# Access Compliance Report

## Public Rights-of-Way

### (Curb Ramps)

Intersection ID: N/A	Main Street: COPPER_WY	Cross Street: CHUCK_HOLLOW_LN	Location: NE
ADA ID: 70C1F8E33E73	Ramp Type: PerpDiag	Initial Pass/Fail: Fail	Overall Compliance: No
Severity Score: 8.75			
Codes/Mitigation Info/Possible Solution		Field Measurements/Component Compliance

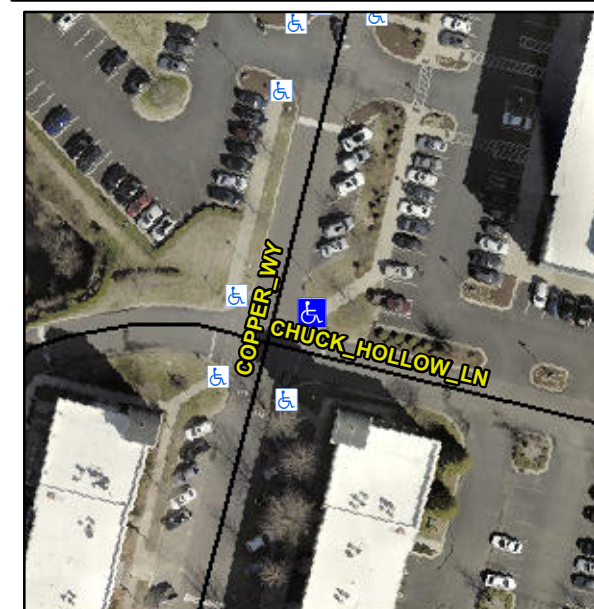
**Not Found, R304.5.1**

Compliance	Description	Data	Compliance	Description	Data
N/A	Ramp Length (in)	61.0	Yes	Ramp Slope (%)	8.2
No	Ramp Width (in)	46.0	Yes	Ramp XSlope (%)	2.0
N/A	Flare Type LT	N/A	N/A	Flare Type RT	N/A
N/A	Flare Slope LT (%)	N/A	N/A	Flare Slope RT (%)	N/A
N/A	Flare Traversable LT?	N/A	N/A	Flare Traversable RT?	N/A
N/A	Landing Length (in)	N/A	N/A	DWS Provided?	N/A
N/A	Landing Width (in)	N/A	N/A	DWS Contrast?	N/A
N/A	Landing Slope (%)	N/A	N/A	DWS Length (in)	N/A
N/A	Landing X Slope (%)	N/A	N/A	DWS Full Width?	N/A
N/A	Landing Curb? (Y/N)	N/A	N/A	DWS Offset (in)	N/A
N/A	Shared Landing?	N/A			
N/A	Gutter Ponding?	N/A	N/A	Gutter Slope (%)	N/A
N/A	Gutter Lip Ht (in)	N/A	N/A	Gutter X Slope (%)	N/A
N/A	Painted X Walk1?	No	N/A	Painted X Walk2?	Yes
	X Walk 1 Direction	To NW		X Walk 2 Direction	To SW
N/A	X Walk 1 Width (in)	N/A	N/A	X Walk 2 Width (in)	55.5
	X Walk 1 Slope (%)	0.6		X Walk 2 Slope (%)	2.9
	X Walk 1 X Slope (%)	0.8		X Walk 2 X Slope (%)	1.5

**Remove & Replace Curb Ramp With Two New Directional Ramps or Equivalent.**
